COMMITTEE:	East Lothian Council
MEETING DATE:	30 September 2025
BY:	Executive Director for Place
REPORT TITLE:	Musselburgh Flood Protection Scheme – Preliminary Decision on Proposed Scheme
REPORT STATUS:	Public

Identification and Evaluation of Potential Modifications to Musselburgh Flood Protection Scheme

Figure 1 Benthic habitats mapped by NatureScot

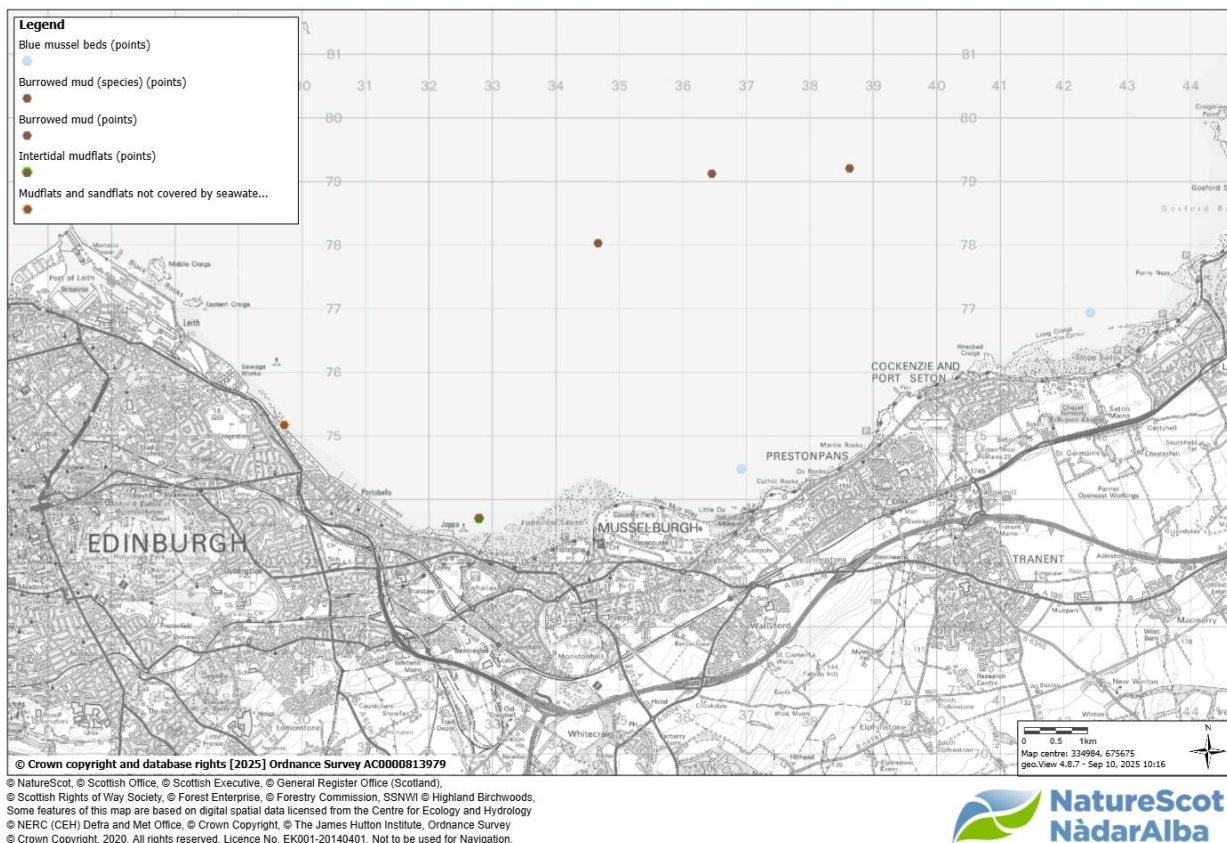
Figure 1). The current HRA (and EIA) does not adequately assess the potential links with, or impacts to, benthic habitats. However, we recognise that the key impacts relate to disturbance and loss of intertidal feeding/roosting habitat for SPA qualifying features (as previously advised under our marine and terrestrial ornithology advice - 17 May 2024).

Based on the information available, and in line with our draft HRA ornithology comments, we advise that there is Likely Significant Effect (LSE) for the conservation objectives relating to distribution and extent of supporting habitat, and potentially structure and function of supporting habitat.
